TECHNICAL INFORMATION

No. 0714

TASCAM CD-RW900/901, Low Temperature Boot up

DATE 22nd June 2007

SCHEMATIC DIAGRAM CD-RW900/901 SYS(1/3): AUDIO SECTION

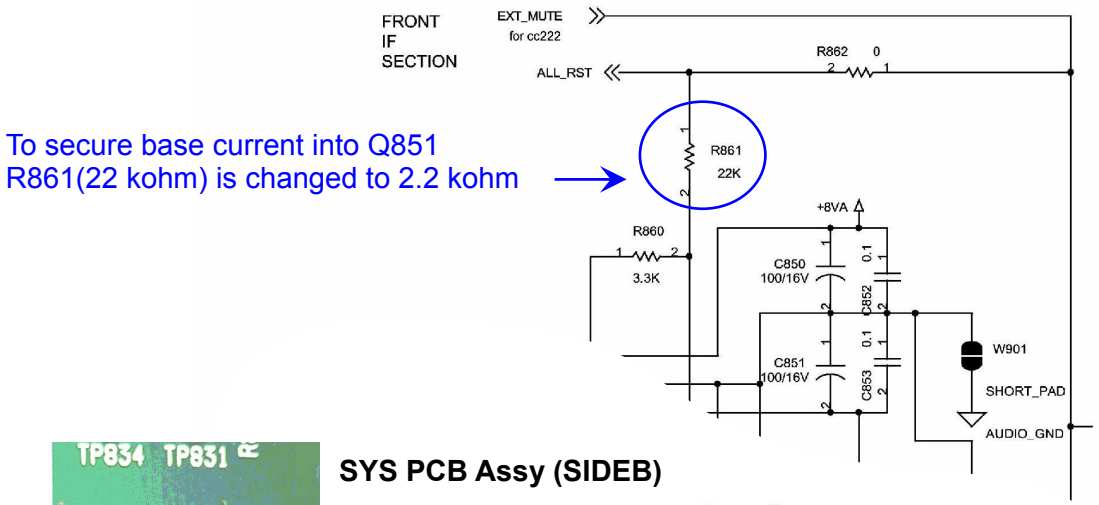
To maintain safer wake up of Q820/920 on Sys (1/3) SCH (C, 7), Power on Mute Trs even under lower temperature environment, the following change has been made on the products with the following:

Symptom: No output or noise on outputs has occurred during several minutes after powering on the unit made at the first attempt in rather cold morning.
Cause: A value of R861 in PDOWN signal pass has been selected to cause a lack of Q851 base current.
Solution: R861 (22 kohm) on Sys(1/3) SCH (D, 2) has been changed to 2.2 kohm.

Old	New
R0156964 RD,1/10W 22 KOHM G	R0156724RD,1/10W 2.2 KOHM G
